WHITEMARSH TOWNSHIP SHADE TREE COMMITTEE

MEETING OF AUGUST 4, 2020 at 7:00 PM

Longfield Farms – SLD # 02-19 – Townhome Development.

Reference: Tree Review

SHEET: 8 OF 30

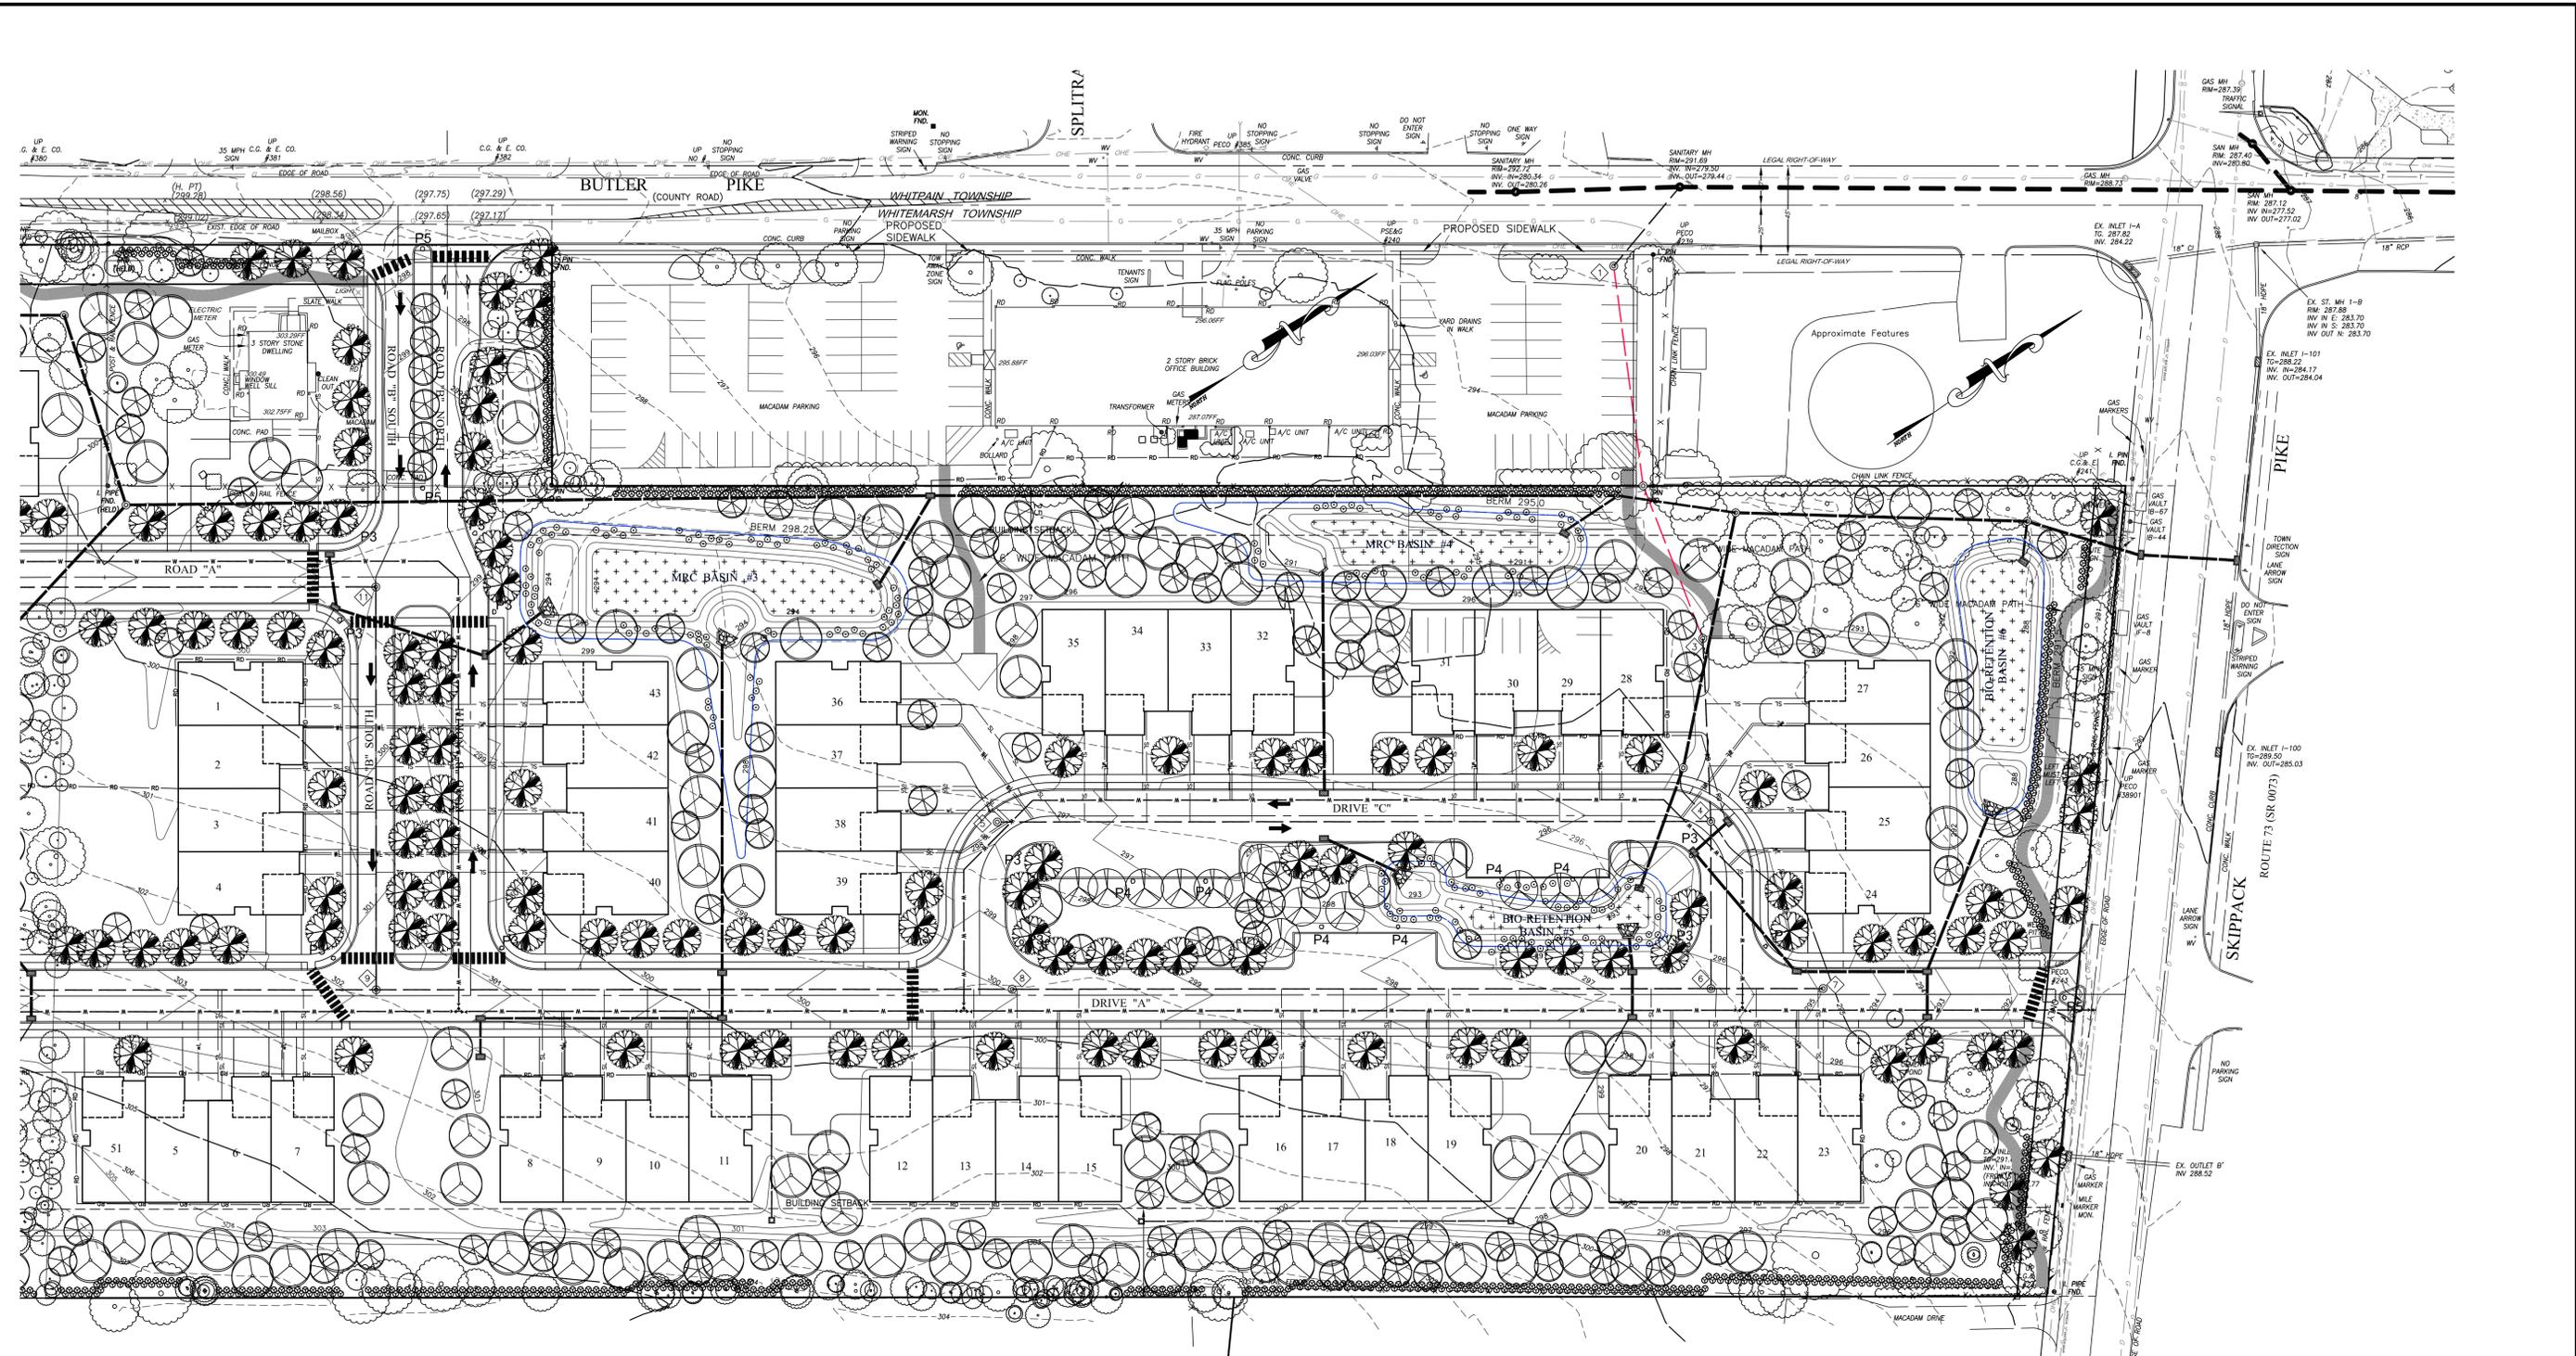
The subject applicant is removing a total of 139 subject trees within proposed development. During two previous site visits and also a final inspection today, I verified and observed a total of 85 trees that are dead, dying declined beyond repair and or failing from numerous tribulations such as standing water, decay diseases, lack of previous care, age and both abiotic / biotic factors. These were observed with the applicant’s planner, Rick Collier. An additional 54 trees are being removed that were deemed healthy and structurally sound. These are being removed obviously for the proposed development improvements. The remaining 223 trees will remain protected on site.

The applicant is removing 38.4% of the total trees. 14.9% of these trees are rated as healthy. In discussions with the applicant regarding a subject heritage silver maple (51.5”), the applicant has modified improvements to maintain this tree in the landscape. All other trees within the project are protected with TPF.

Removing > than 50 Of total tree count	No – 38.4%
Tree protection fence noted	Yes
Use of natives	Large percentage of the plant palate is native
Utilization of property to ensure that that use of shade trees is maximized	Yes – the applicant is proposing open space, recreation, trails and possible tot-lot in the future.
Diversity mix	A very balanced diversity species mix is being utilized.

The applicant is proposing the utilization of both shade trees, ornamental, evergreen and the use of shrubs to meet the requirements. As noted in the table above, the applicant has designated open space zones for multi-use applications. This will reduce the areas where canopy trees can be planted.

The subject landscape utilizes a broad range of natives with a small palate of non-natives. The landscape action plan will most certainly provide a very balanced multi-level (large canopy/sub canopy and shrub layer). I believe this plan is very well suited for the site as it relates to the species.
